Addendum # 2

Bid Opportunity: 25-7639-RFT - Alpine Public School HVAC Upgrade

RE: Alpine Public School – HVAC Upgrade
Kitchener, ON

ADDENDUM 01

SCALE	AS NOTED	PROJECT	24138
DATE	JAN. 2025	DRAWING	M100
DRAWN	IE / EH	CHECKED	AA / AD
PRINT DATE	JANUARY 25	CAD FILE

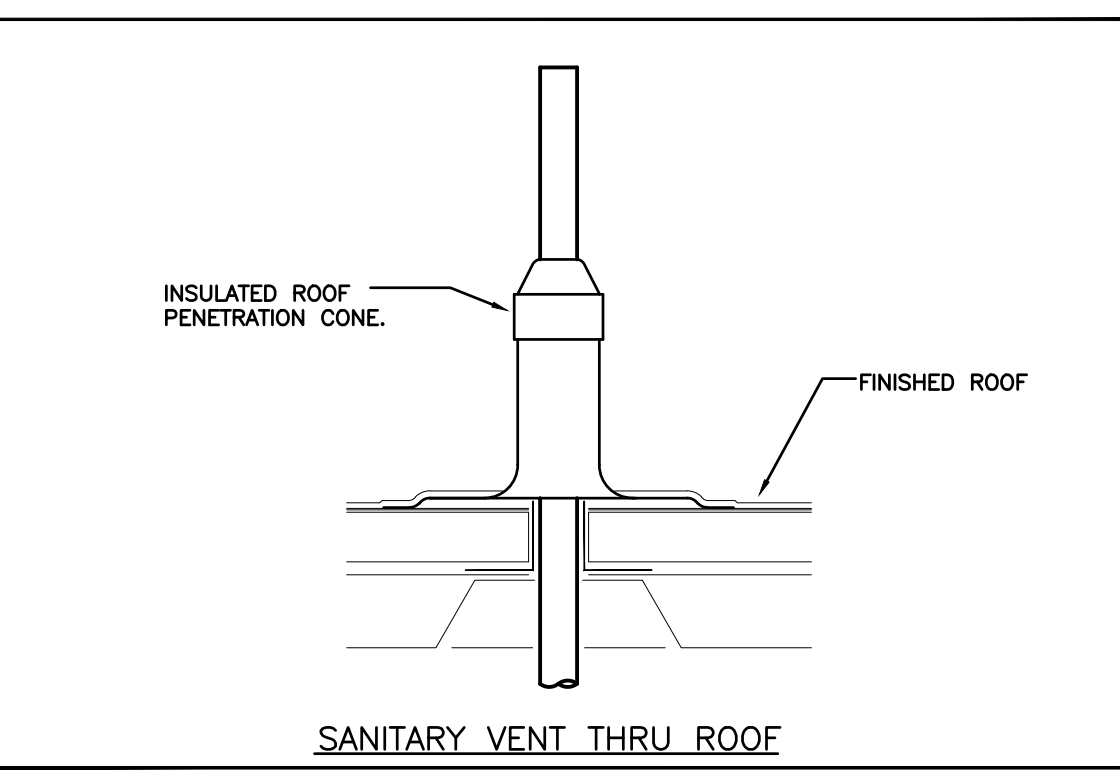
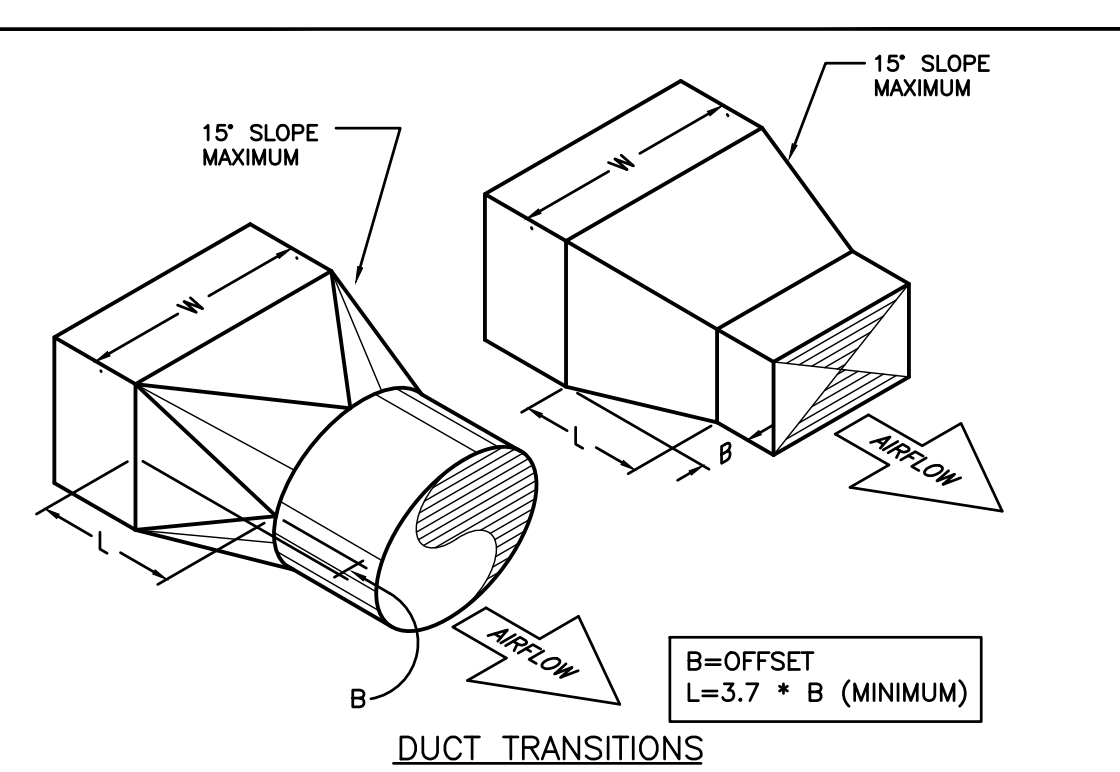
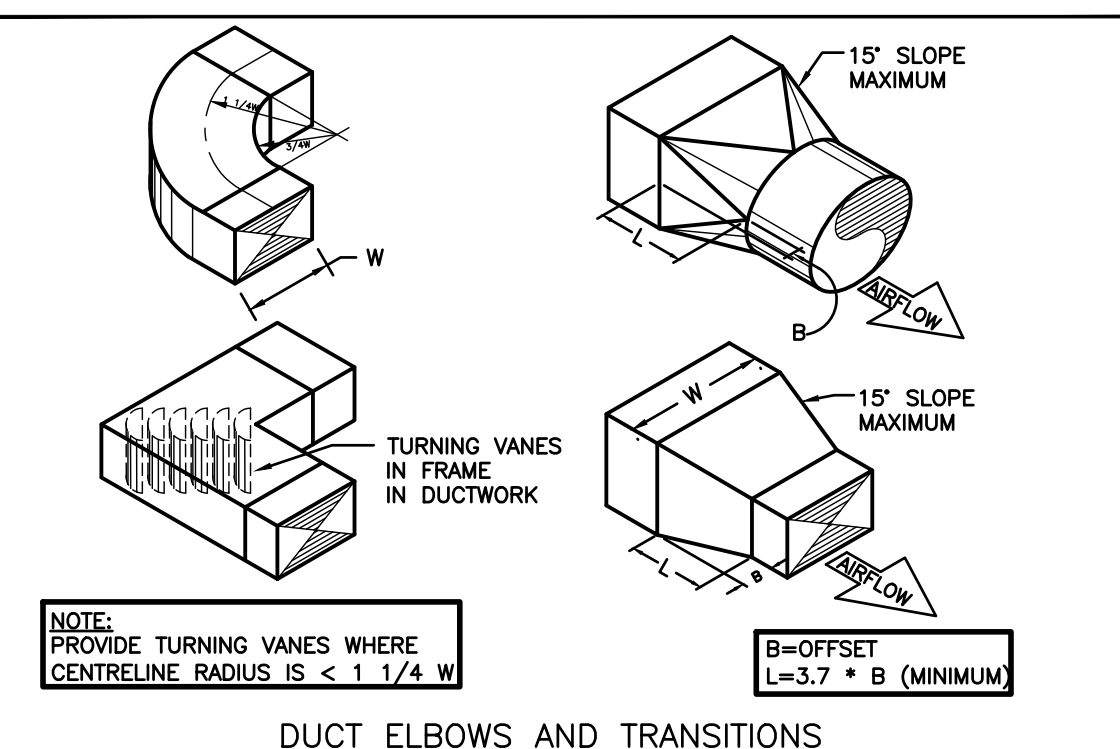
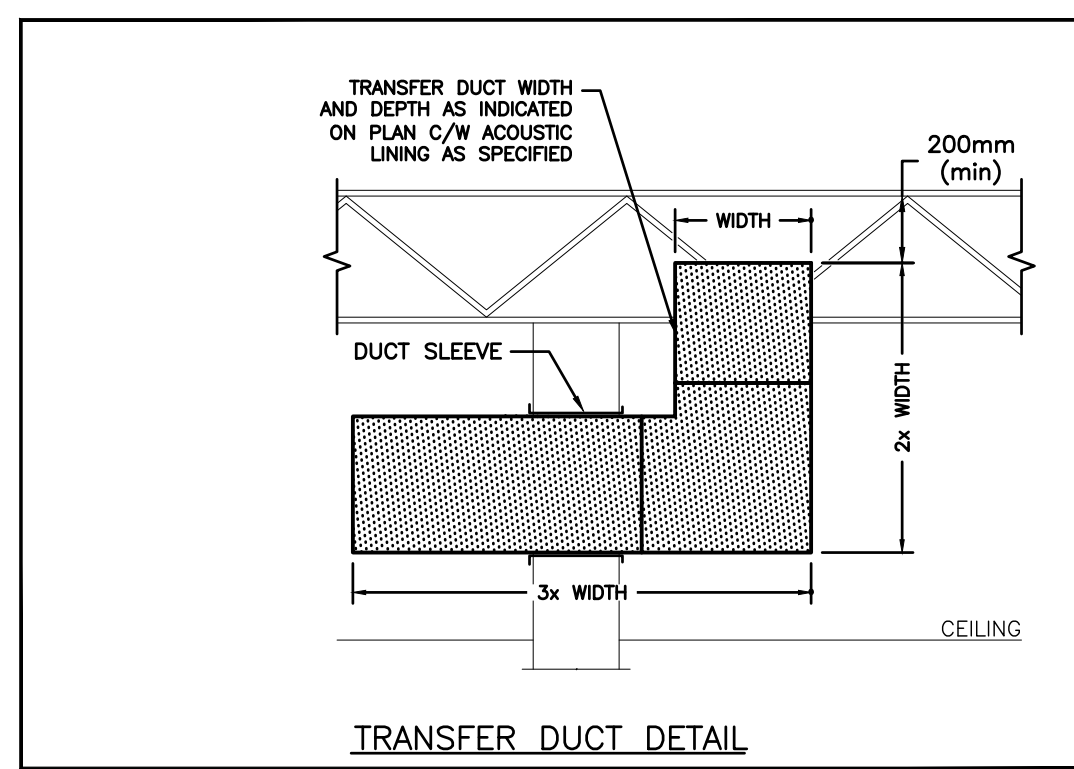
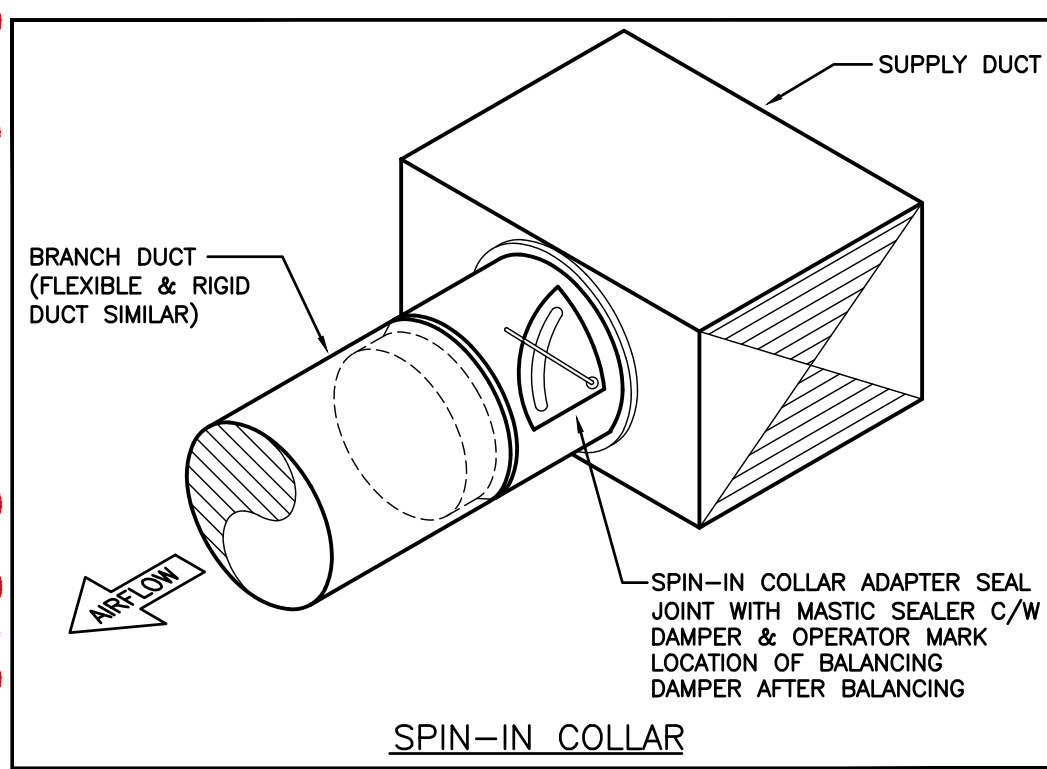
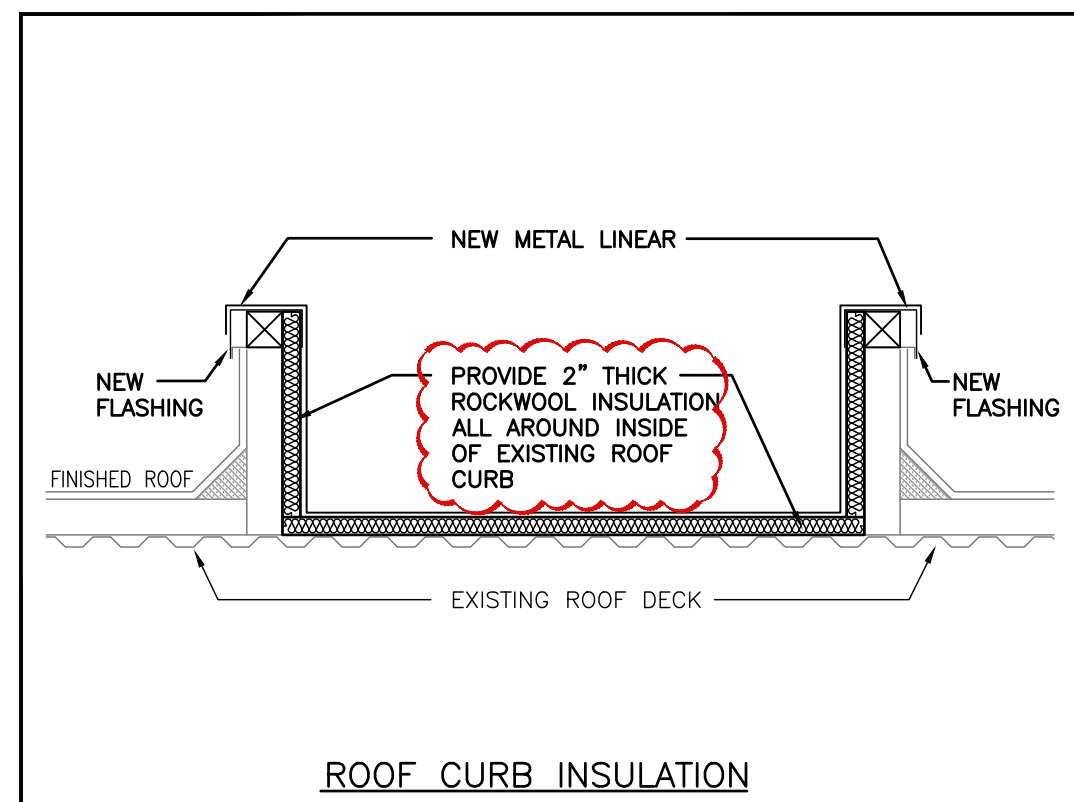
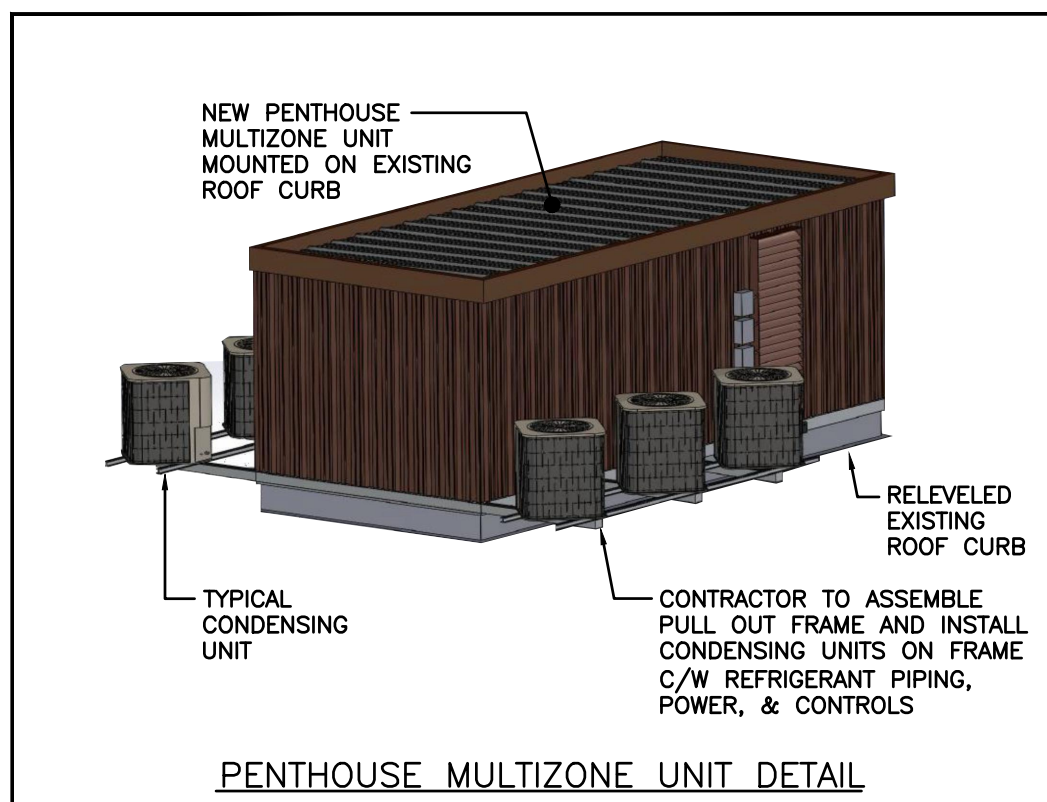
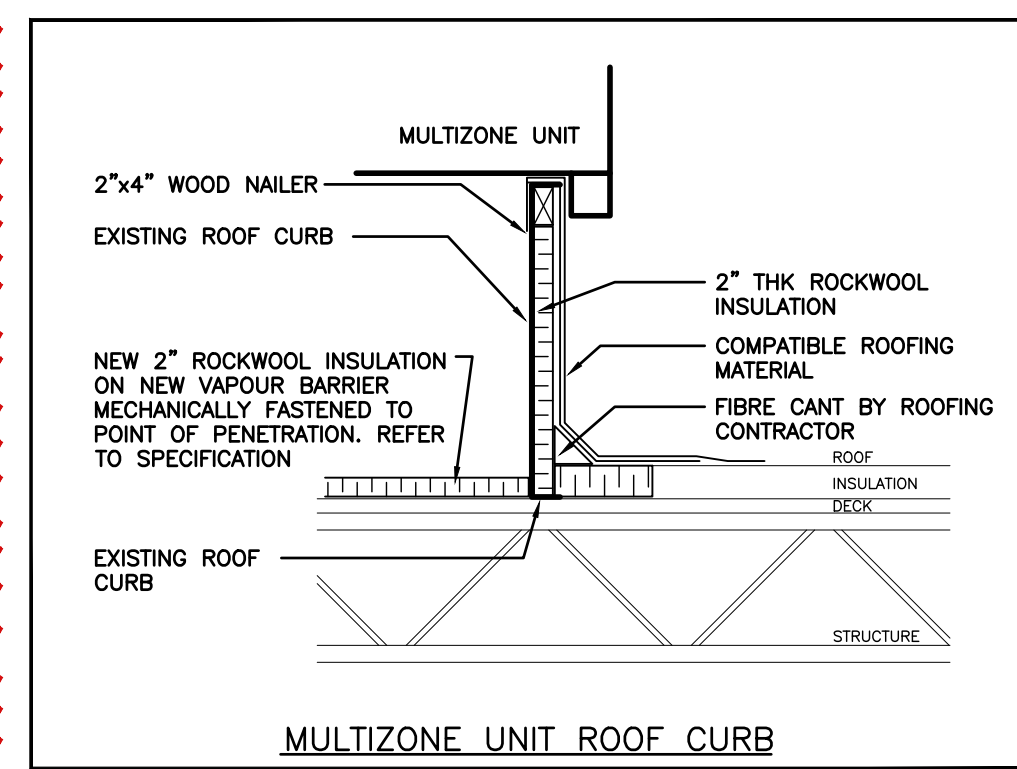
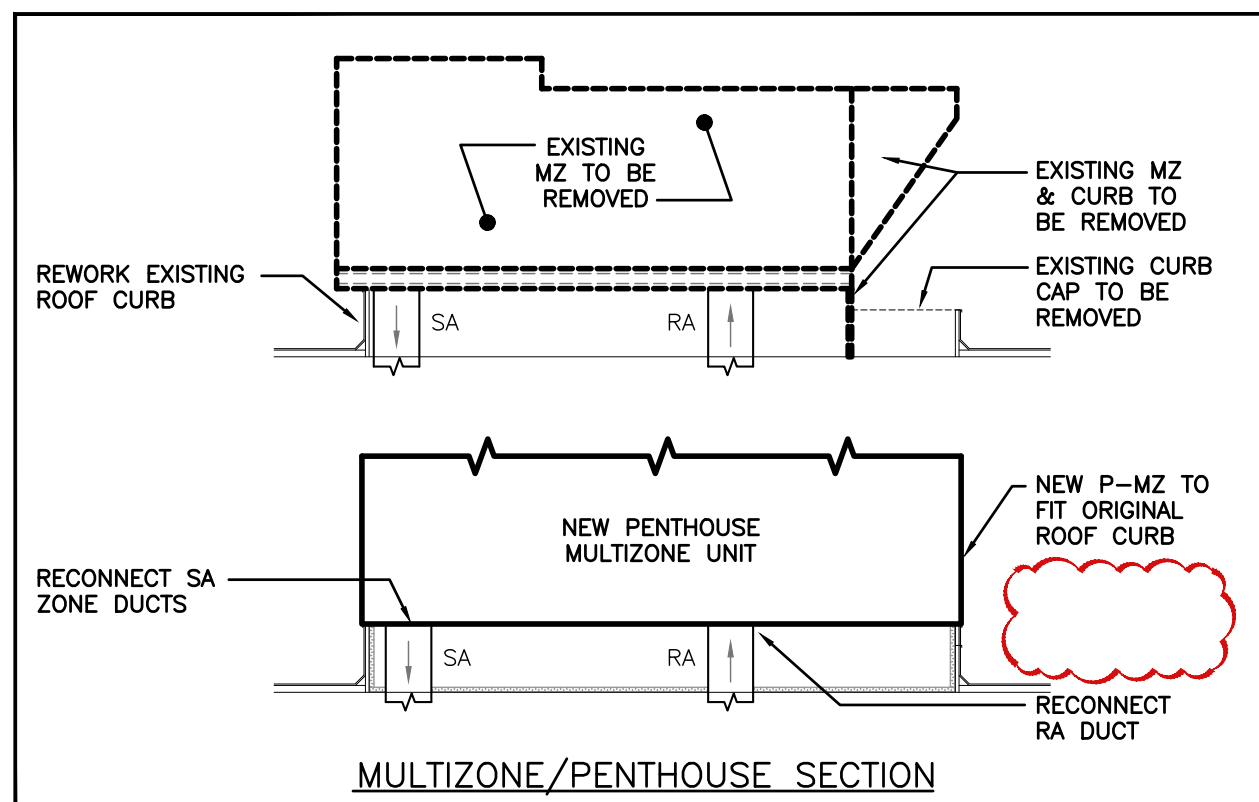
2.0 Reference Attached Reissued Drawing M100

.1 Revise various schedule remarks as shown.

.2 Revise 'Multizone Unit Roof Curb Details' as shown.

GROUND FLOOR PLAN DEMOLITION

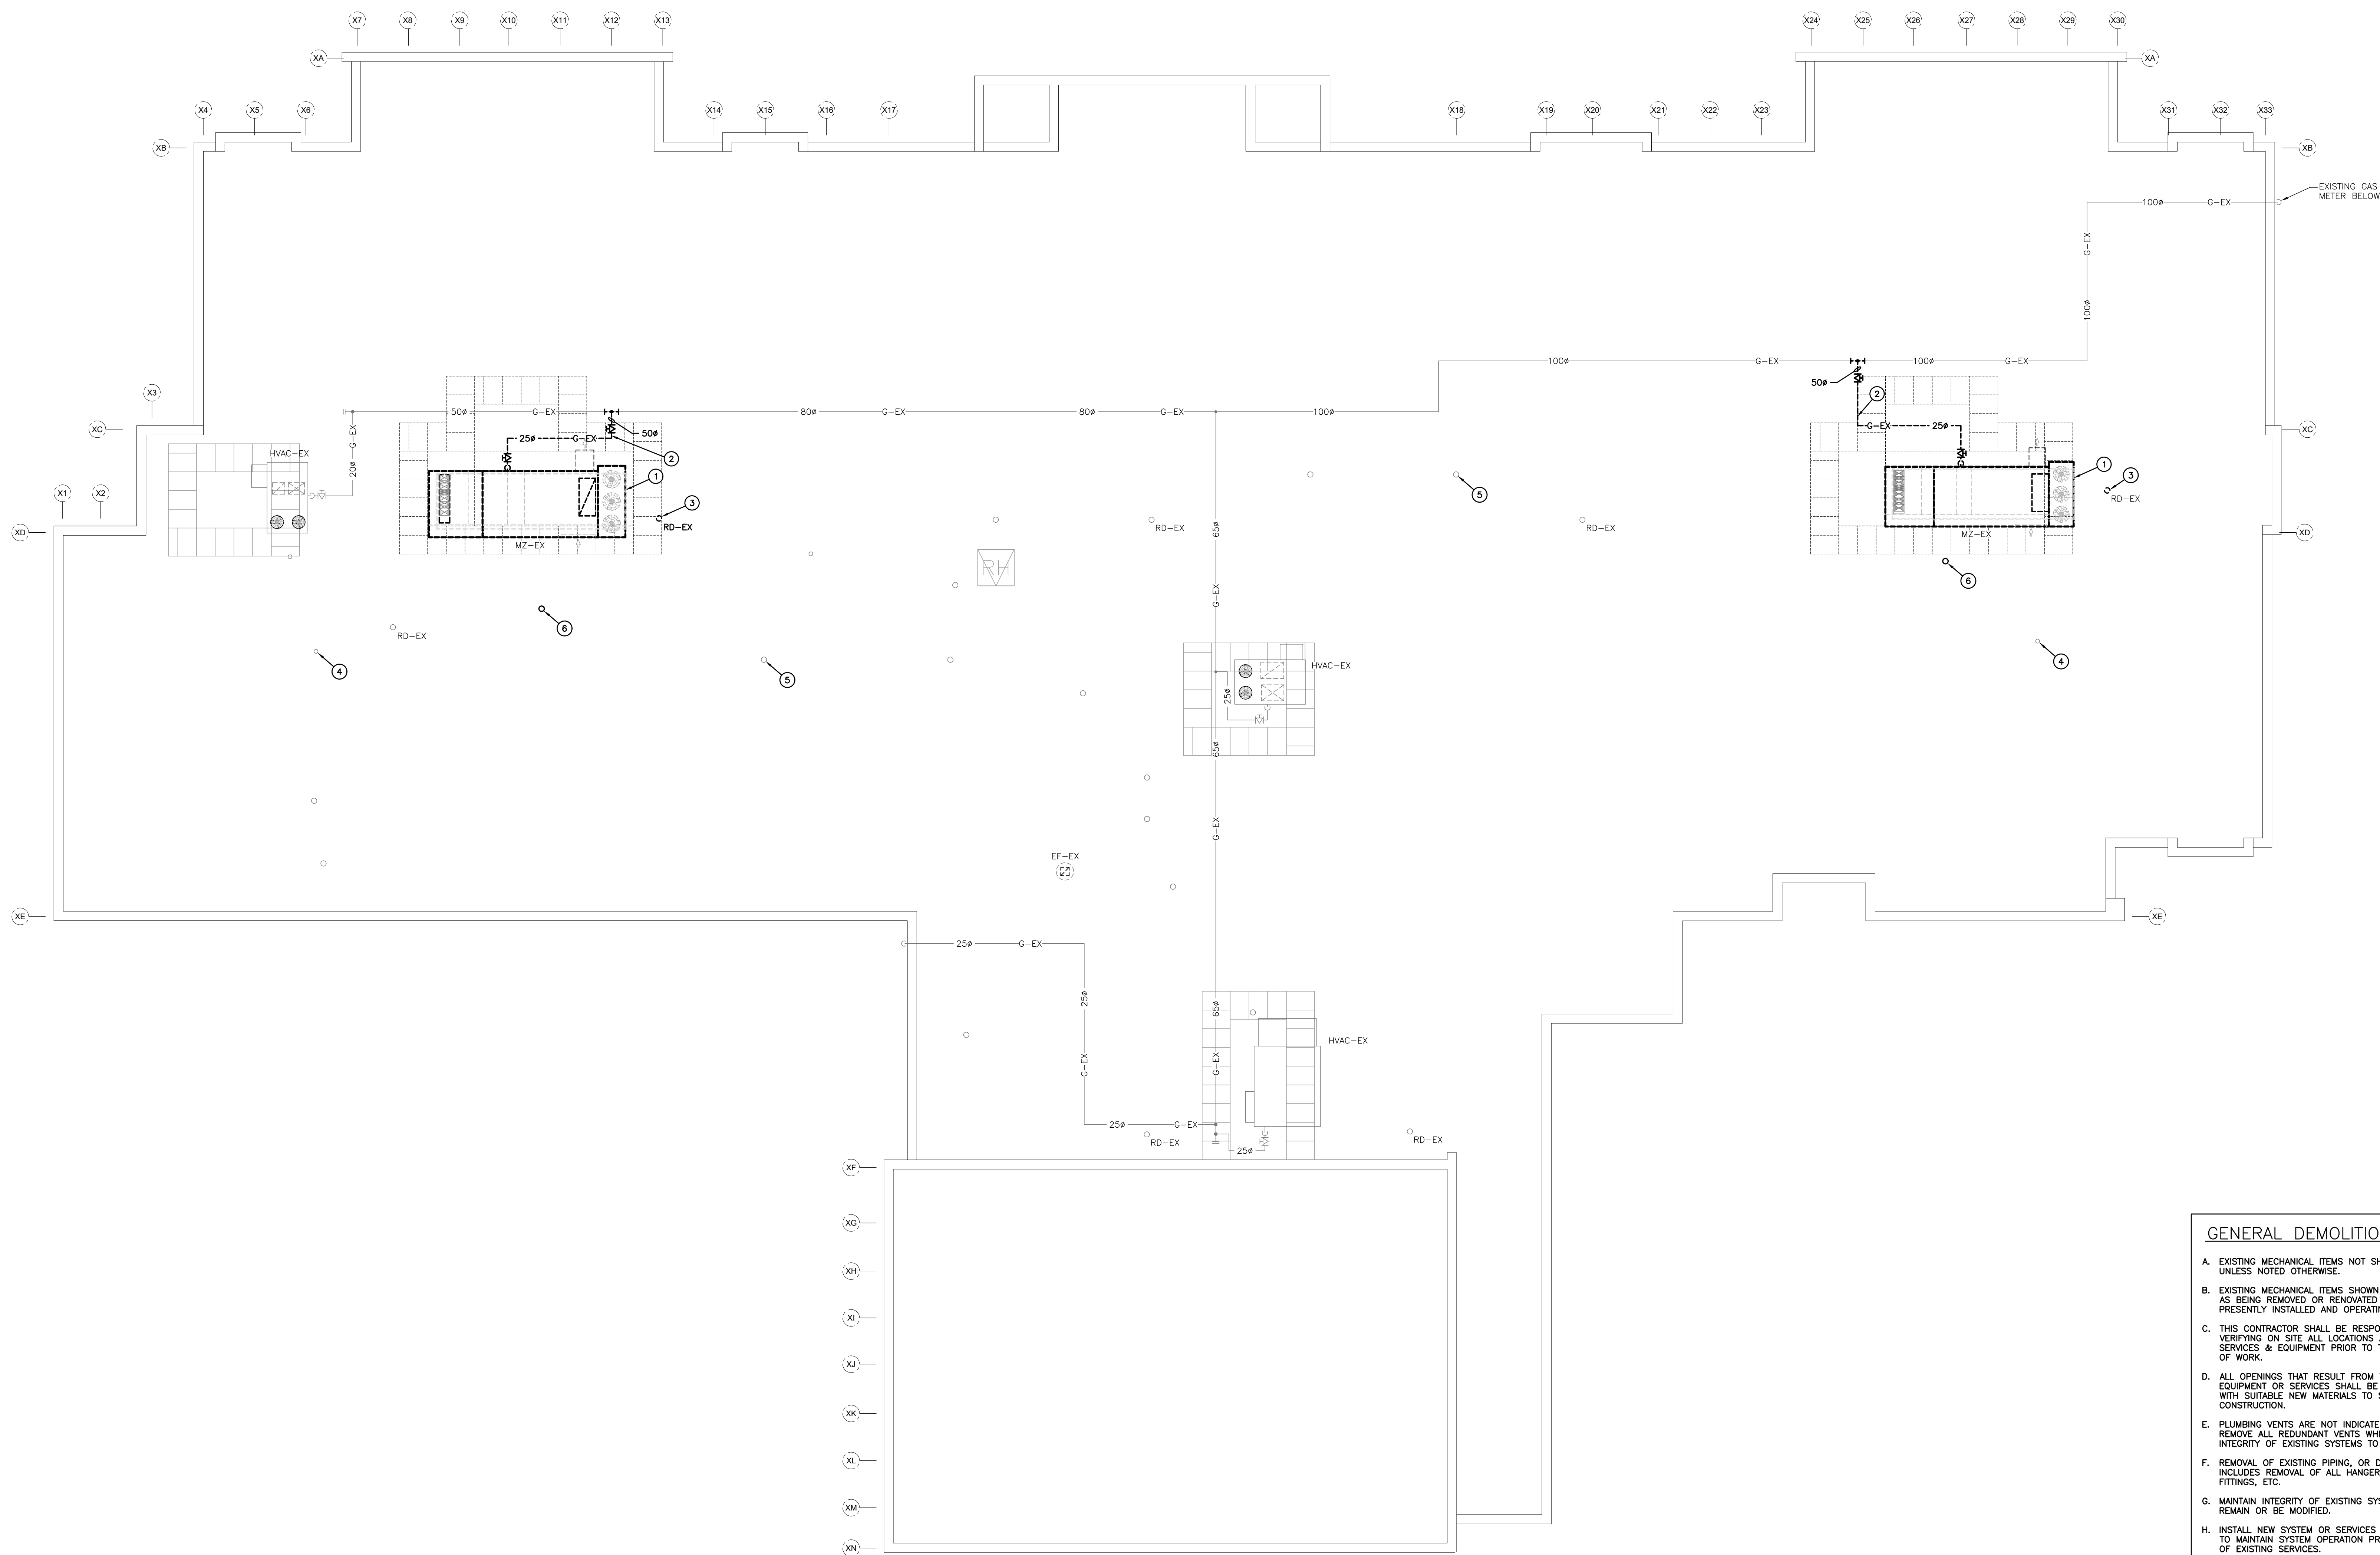
Item 3**3.0 Reference Attached Reissued Drawing M201**

- .1 Existing standpipe system is not required. The contractor shall drain entire piping system and remove associated hoses. Existing fire extinguishers shall remain located in cabinets. Refer to attached reissued drawing M201.

1. EXISTING STANDPIPE SYSTEM IS NOT REQUIRED. THIS CONTRACTOR SHALL DRAIN ENTIRE PIPING SYSTEM AND REMOVE ASSOCIATED HOSES. EXISTING FIRE EXTINGUISHERS SHALL REMAIN LOCATED IN CABINETS.
